AGENDA
JULY 28, 2026
CITY OF LAVON
PLANNING AND ZONING COMMISSION
CITY HALL, 120 SCHOOL ROAD, LAVON, TEXAS
6:30 PM

Re: Take 5 Oil Change
Zoning Change and Site Plan Review
LJA Job No. NTP3880
MyGov Submittal: June 26, 2026

Re: Take 5 Oil Change
Zoning Change and Site Plan Review
LJA Job No. NTP-40467
MyGov Submittal: May 29, 2026

L1.0
LANDSCAPE PLAN

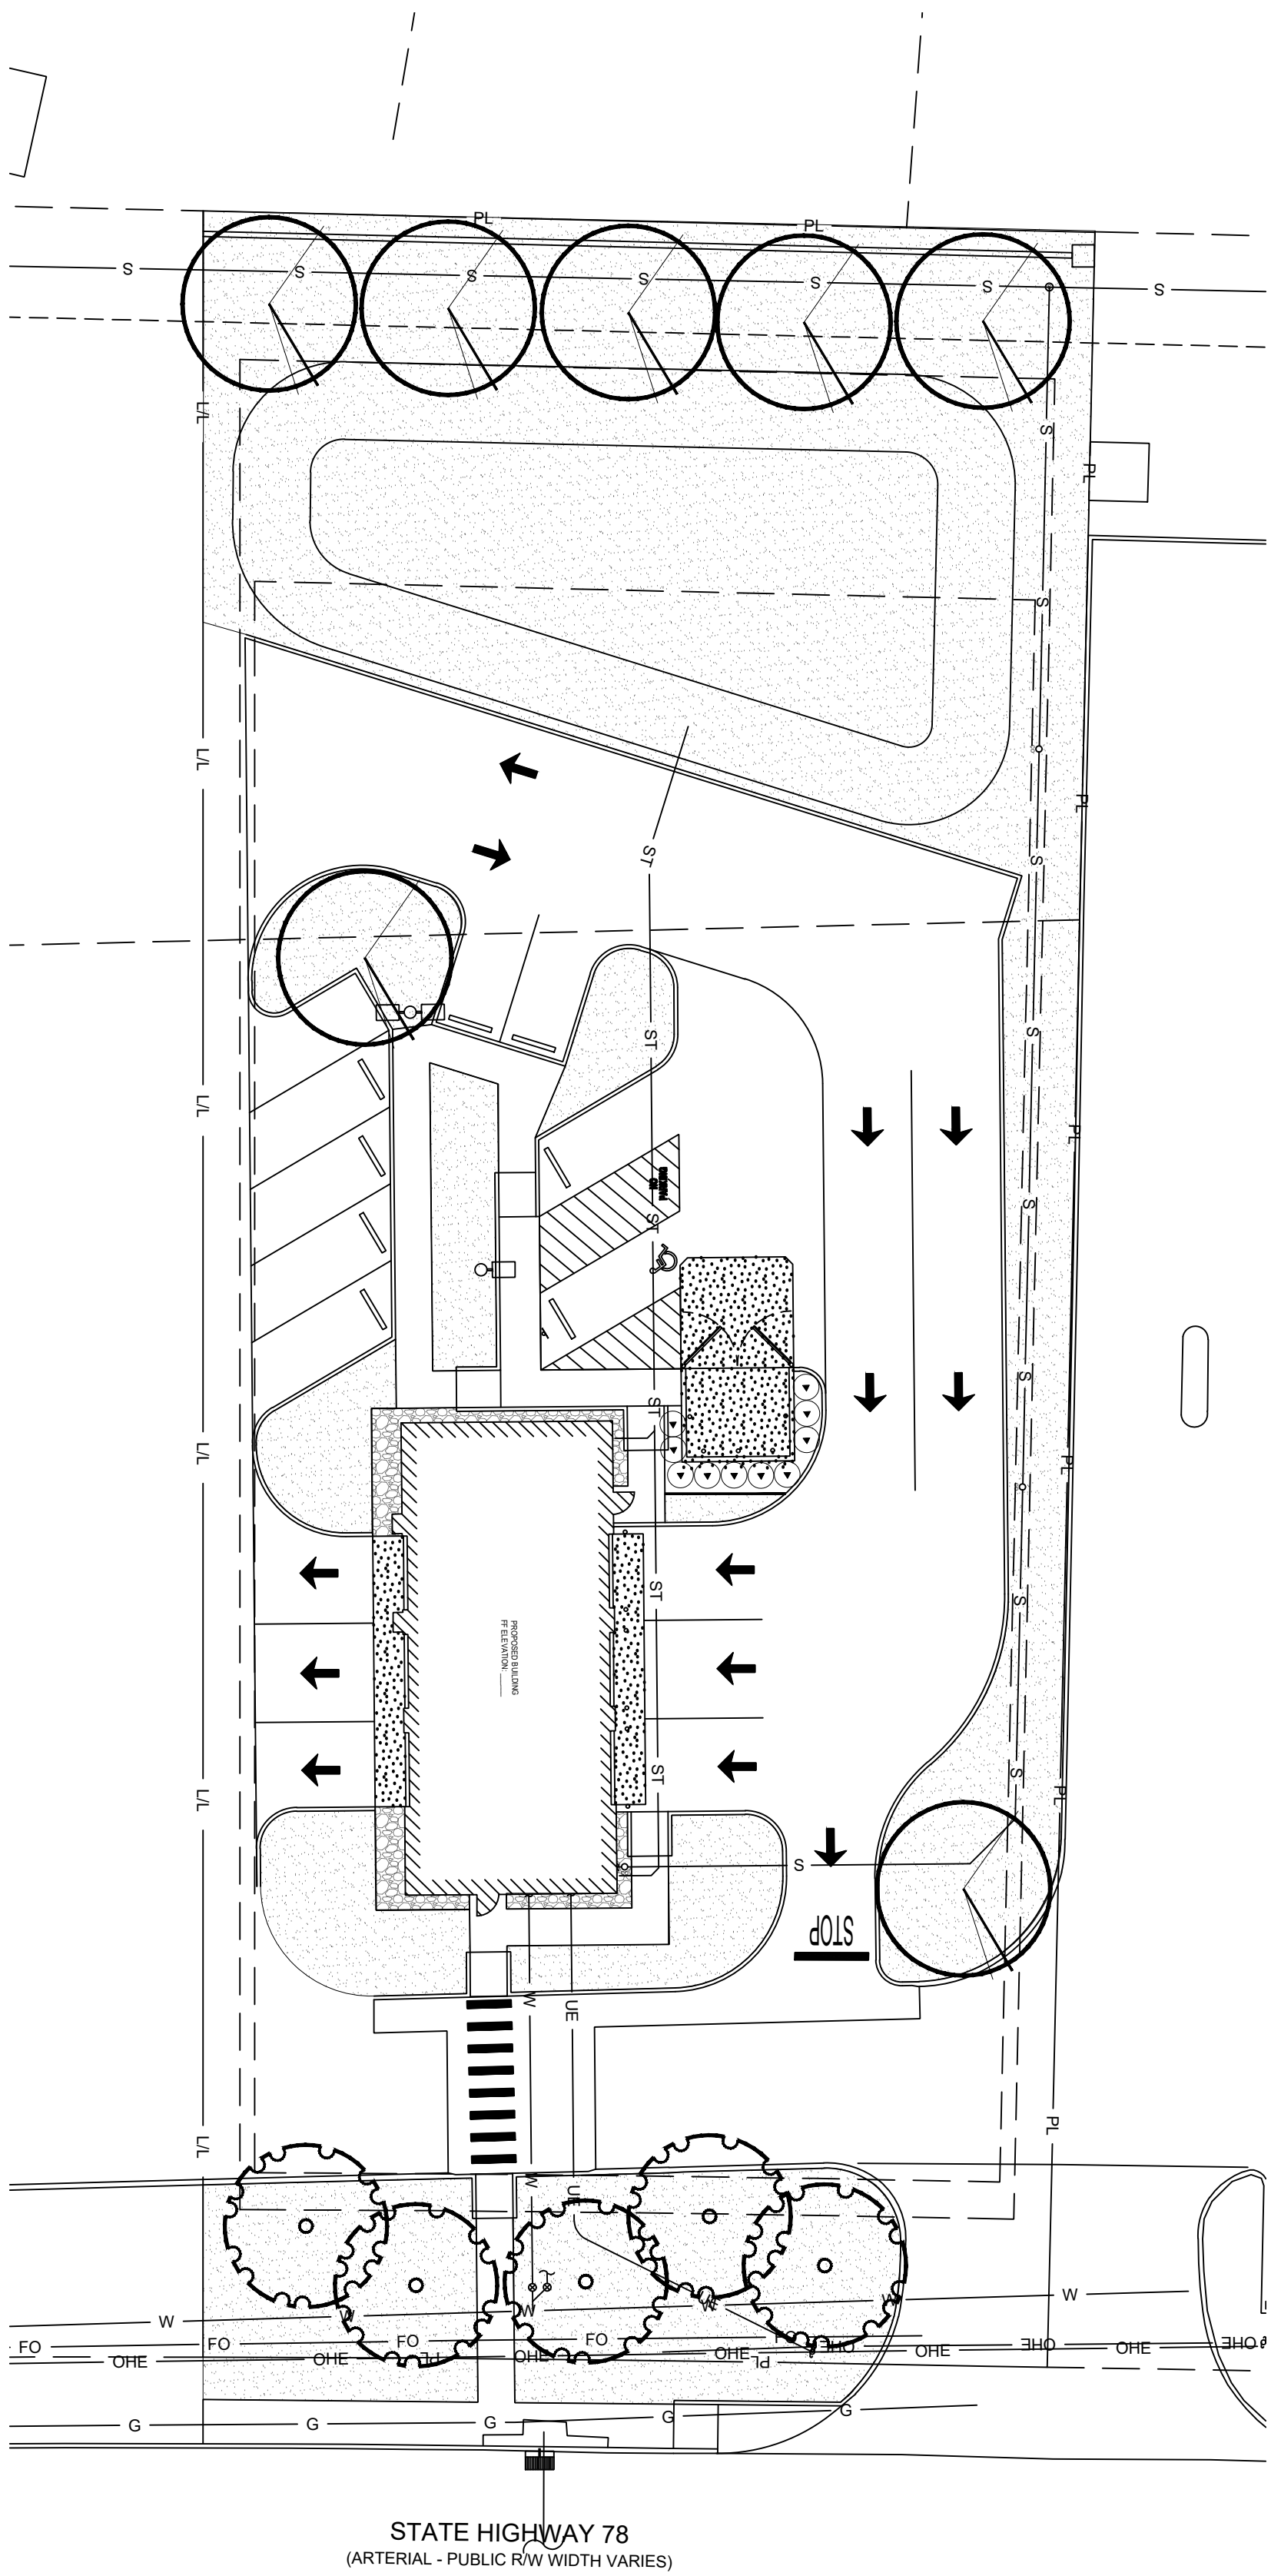
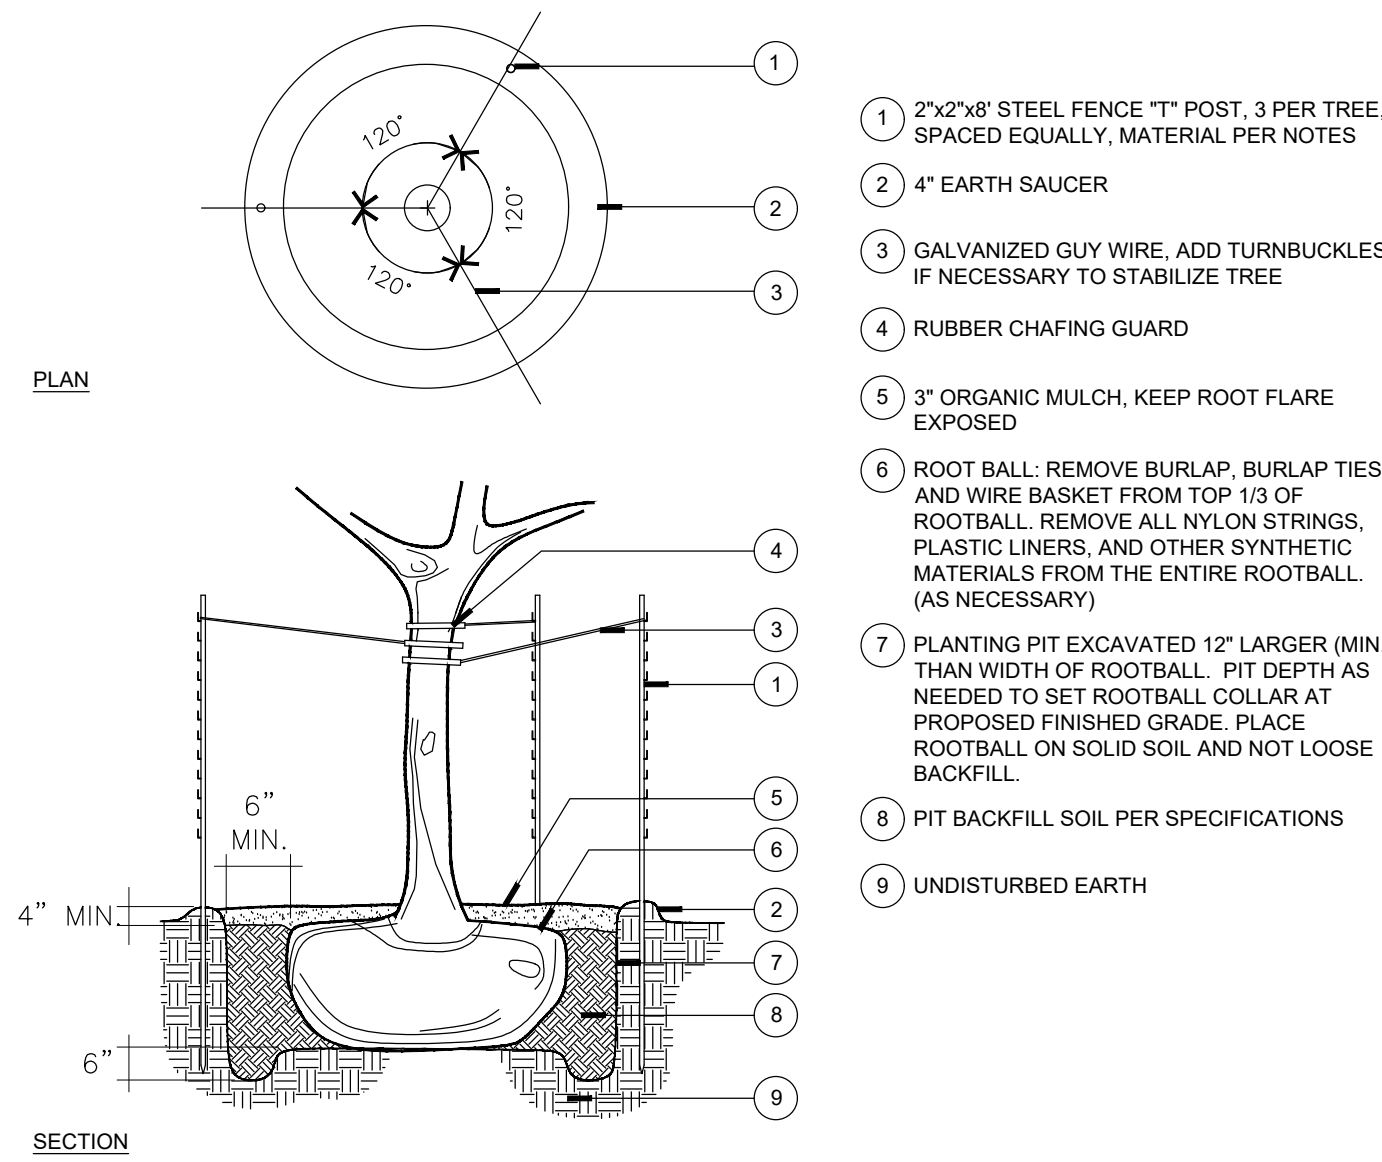
11. All proposed trees must be a minimum of eight feet from public utility lines. Revise the landscape plan to comply with this standard accordingly.
12. Revise the Landscape Plan to add required terminus canopy trees, within landscape islands, at the terminus of each parking row, as shown below in red.

13. Revise the Landscape Plan to label all proposed surface materials.
